**RE: TRANSPORTATION IMPACT STUDY ADDENDUM LETTER & RESPONSE TO COMMENTS  
152-164 BATHURST STREET AND 623-627 RICHMOND STREET WEST  
ZONING BY-LAW AMENDMENT RESUBMISSION**

The purpose of this Transportation Impact Study (TIS) addendum letter (herein referred to as the "February 2025 TIS Addendum Letter") is to provide an update regarding the transportation-related aspects of the development proposal as a result of the building height reduction and adoption of the Toronto Green Standard, Version 4.0 ("TGS V4") requirements replacing the former Toronto Green Standard, Version 3.0 ("TGS V3") requirements.

### 6.1 City of Toronto Development Engineering Memorandum – November 26, 2024

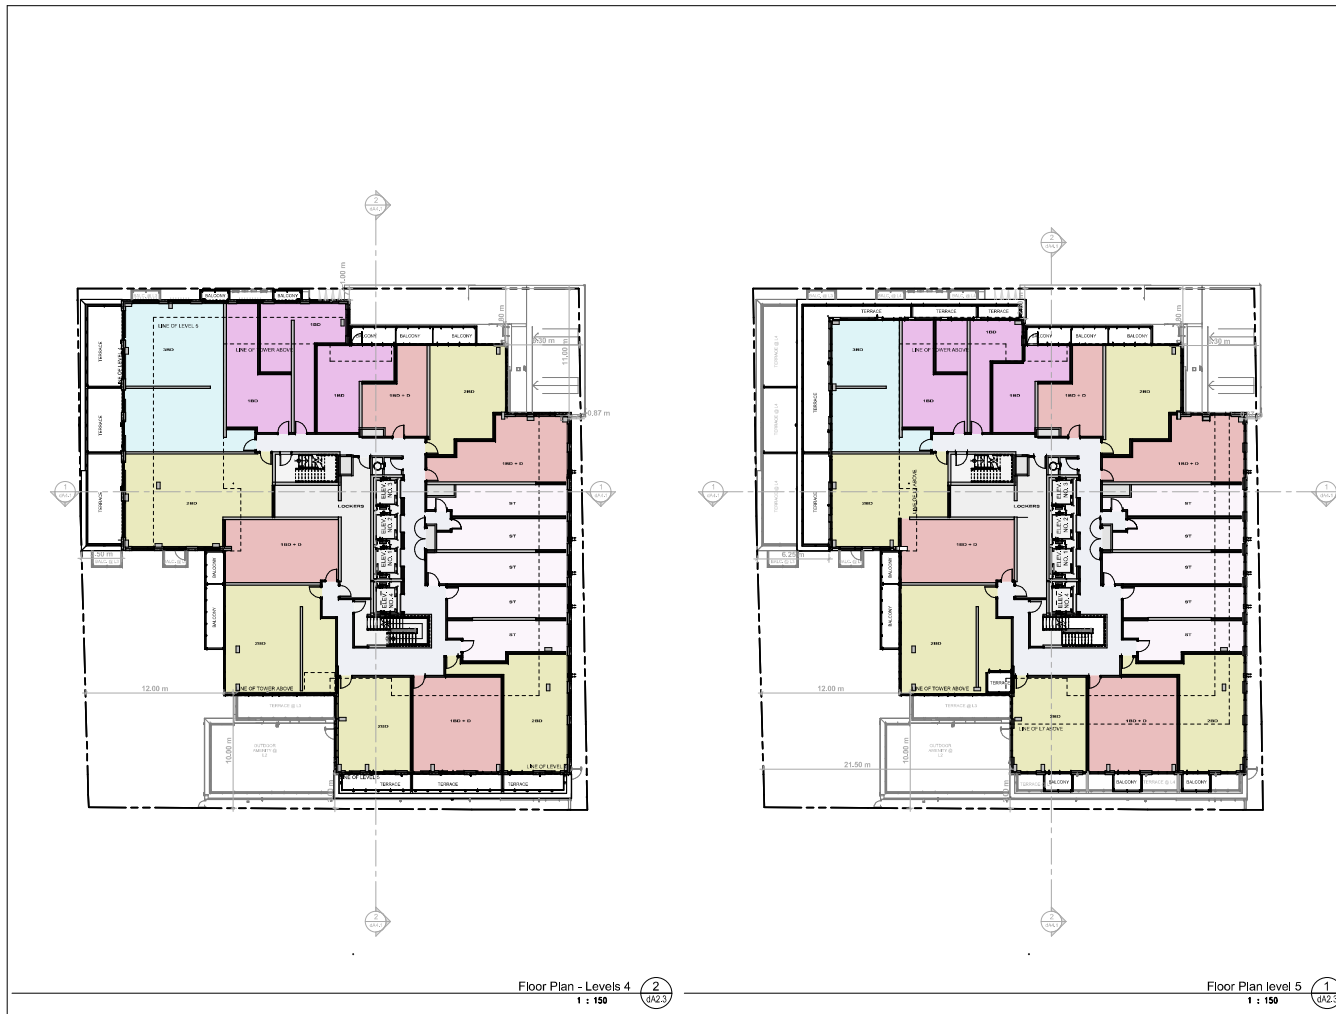
- i. Revised drawings must indicate and annotate the Type G loading space and Staging Pad is level (+/-2%) and is constructed of a minimum of 200 mm reinforced concrete. Type G loading space notation missing.
- ii. Revised drawings must ensure location of chute/sorter system allows for enough space to allow the bin or each material to be changed out without requiring movement of the other two bins.
- iii. Revised drawings must ensure that all doorways along the path to the staging pad are double doors or roll-up doors.

The Type 'G' space annotated, and staging pad specification is provided. See dA1.3 and dA2.1. The chute ensures adequate room to manoeuvre bins, and all doorways between compactor and staging pad are double doors.
